ISSUE: Certificate of Appropriateness for alterations

APPLICANT: Emily Lapp

LOCATION: Parker-Gray District
415 North Peyton Street

BAR #2019-00448
415 North Peyton Street

Figure 7: To-scale drawing showing proposed alterations to front façade. One square (1/4") equals 1 foot.

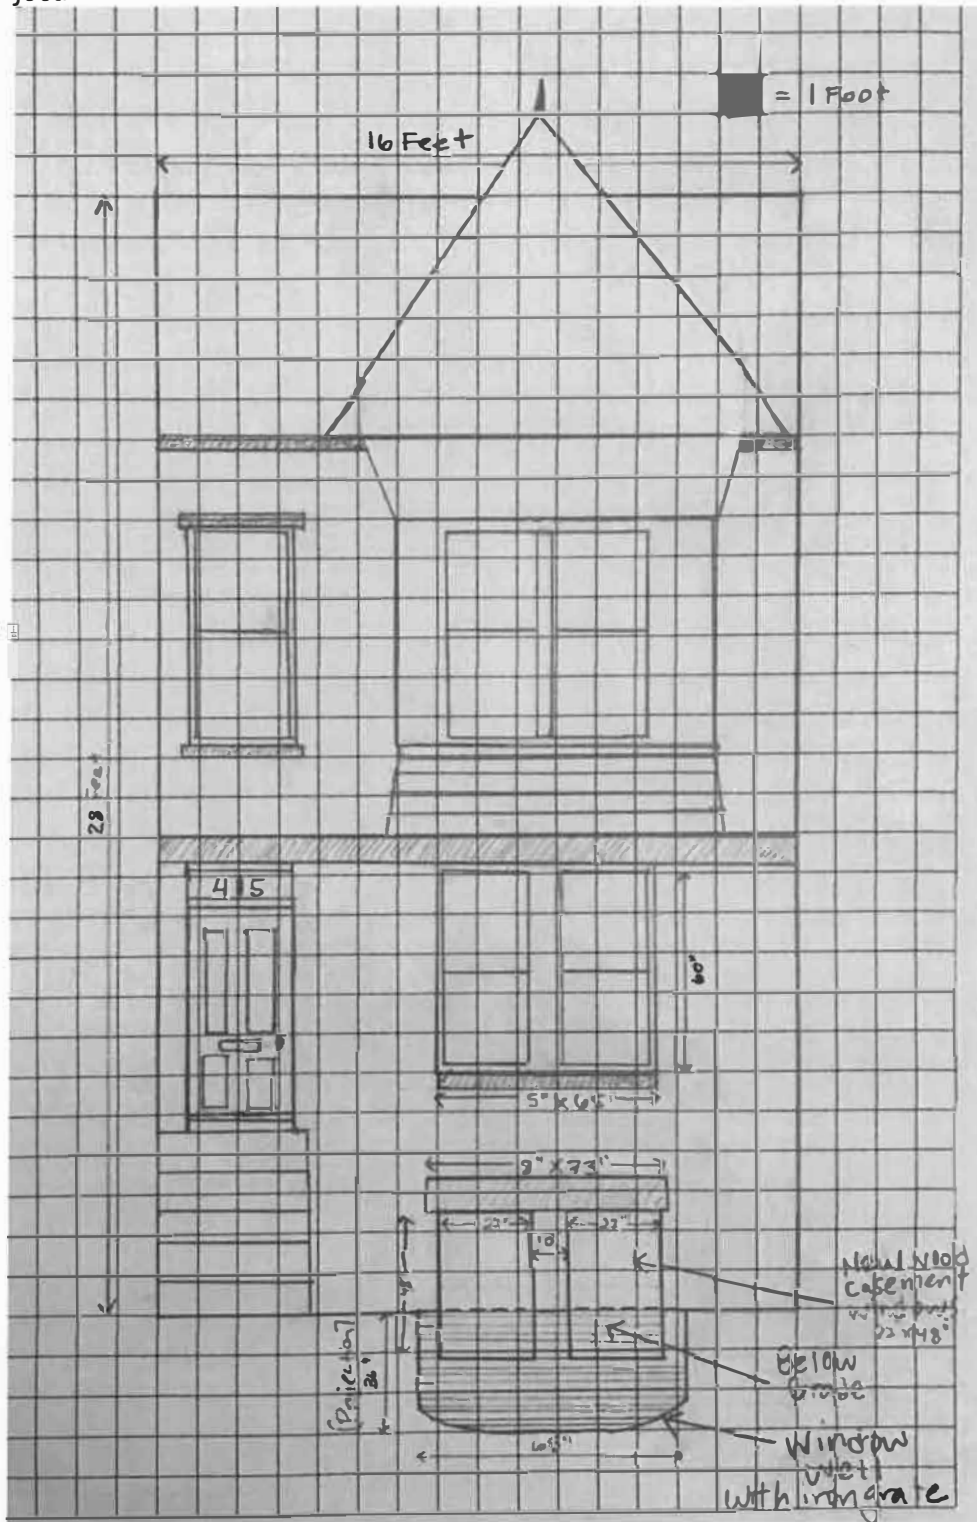
The *Design Guidelines* state that windows are a principal character defining feature of a building and serve both functional and aesthetic purposes. The proposed alterations include the conversion of the existing basement windows into two egress windows, as required by code for all sleeping rooms. The replacement windows will retain the width of the existing windows (27") and the lintels will remain fully intact. The existing window sills will be removed to allow for the window openings to be lowered 20" and, as previously stated, the egress window well retaining walls will be nearly flush with the existing grade and will not be incompatible with the architectural character of the building as viewed from the sidewalk.

While staff compliments the very clear and thorough application materials, the applicant must, nevertheless, submit final window order form from the vendor to confirm that the window glazing complies with the Alexandria New and Replacement Window Performance Specifications in the Historic Districts with respect to materials and glass color before ordering or applying for the necessary building permits.

1. Submit final window specifications to confirm that the window glazing complies with the Alexandria New and Replacement Window Performance Specifications in the Historic Districts before ordering the windows or applying for building permits.

Figure 17: Plat showing location of window well

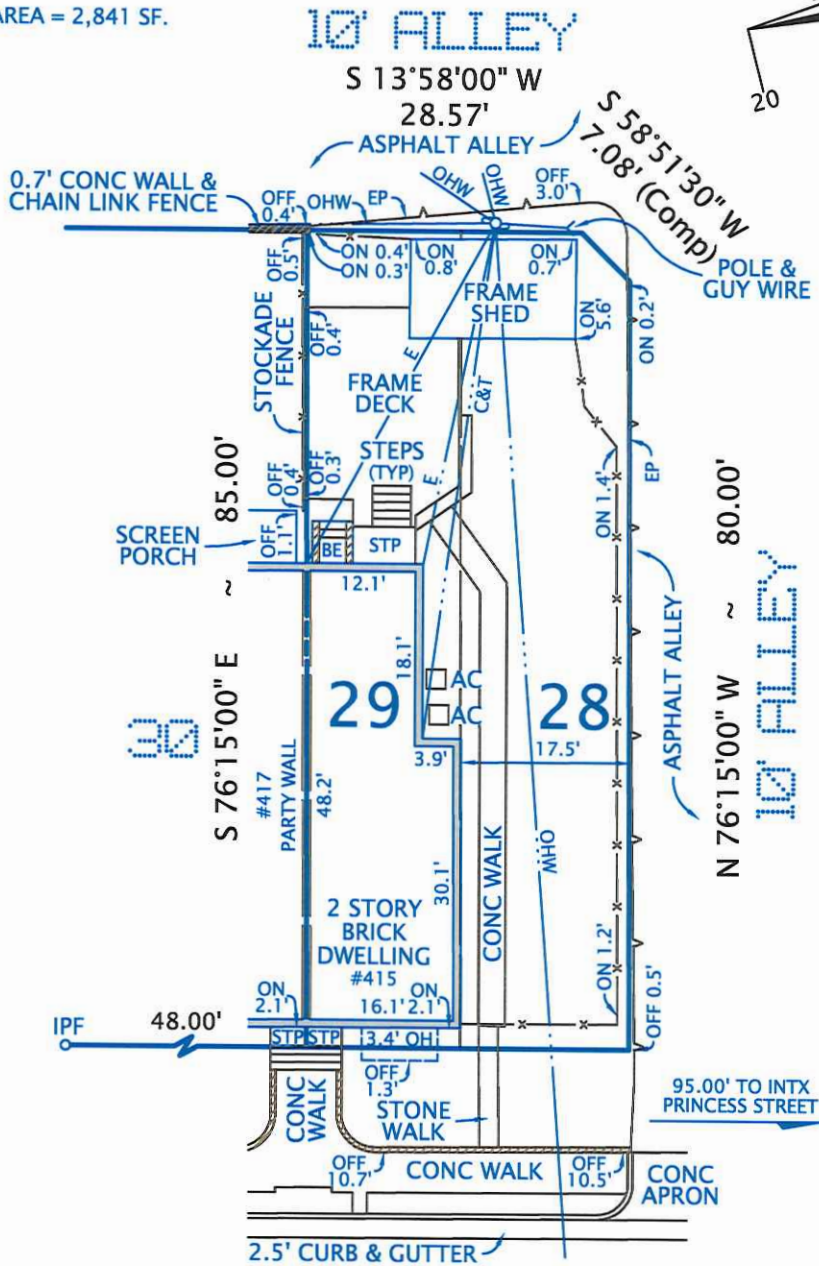
Staff notes that, although the building façade is set back approximately 12' from the sidewalk, the window well will still project 1.3' into the public right of way. However, basement windows wells covered by flush grates are frequently approved by the BAR that are entirely within the public sidewalk and the proposed alterations will have a minimal visual impact on this particular site. The new window openings will also retain the existing window pattern and relationship with the windows on the upper stories. Since a large portion of each egress window will be below grade, the windows will not overpower the existing façade, enabling the current windows on the first floor and bay window on the second floor to remain the prominent architectural features on the façade. The proposed metal grate is also minimally visible.
